MEMORANDUM

To: The Design Advisory Board
From: Mary O'Neil, AICP, Senior Planner
RE: ZP 13-0979CA 91 North Winooski Avenue
Date: May 14, 2013

Request: Convert existing accessory structure to one residential apartment (there are 3 existing units; four proposed); construct staintower, changing roof; adding rooftop deck.

Outdoor Condensing Unit
Location

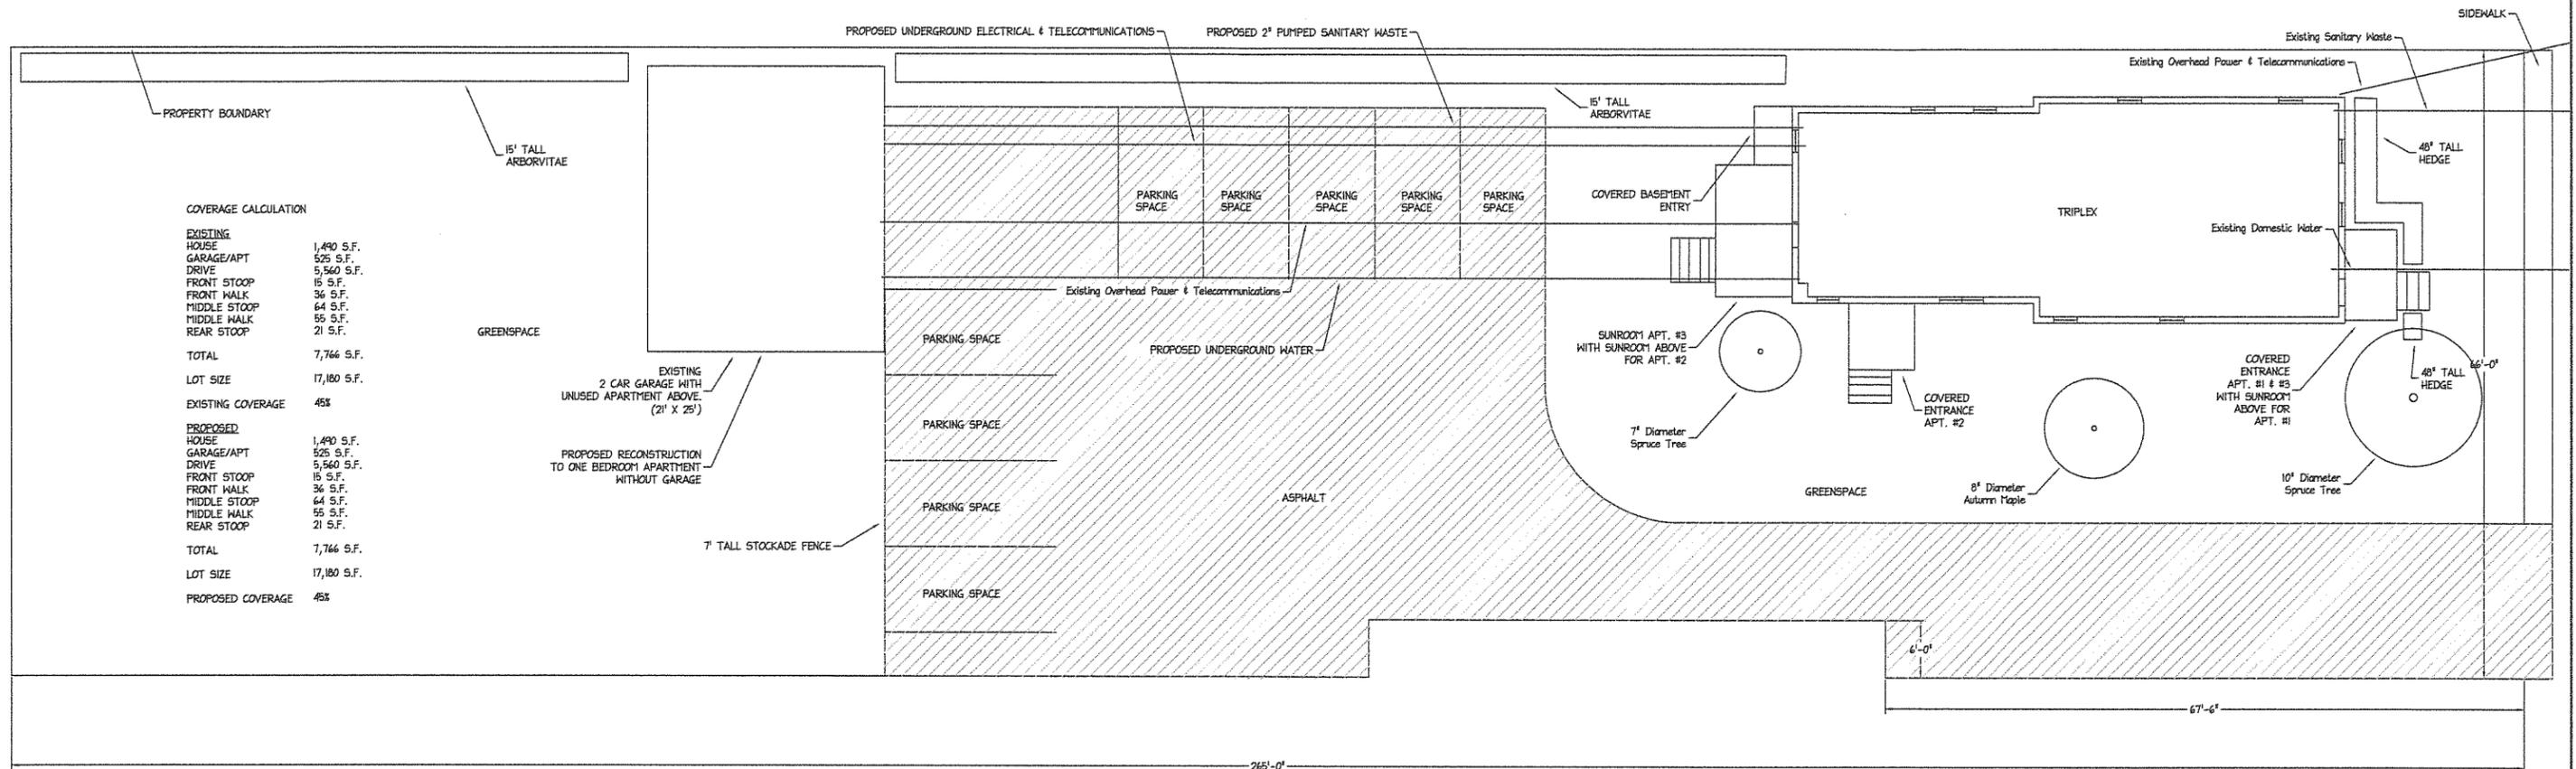
Additionally, the proposed condensing unit is situated in the front (northeast) corner of the roof, and at almost 5' in height, will unfortunately be extremely visible. Its relocation; perhaps to the rear of the site, is highly recommended.

The flat roof (slight shed with parapeted sides) is one of the most character defining features of the structure (as noted in the Vermont State Register listing), and is recommended for retention. The condensing unit should be relocated to reduce its visibility. A ground mount, behind the building would be a better choice.

The proposed compressor, which as proposed is in excess of the 1' in height noted and intended for the roof of the structure, is not "incorporated into the structure's design, and arranged to minimize visibility." Relocation to a less visible location, preferably along the side of rear of the property, would meet this standard. An estimated decibel level reading (40-50) would suggest the same noise level as a driving rain, but may not be appreciated around the clock by neighbors. Relocation to an area that would be screened from other residential units and minimize audible levels would be required by this standard.

2. Relocation of the compressor to an exterior pad to be located on a side or rear elevation. This will be noted on a revised site plan. Additional screening may be required.
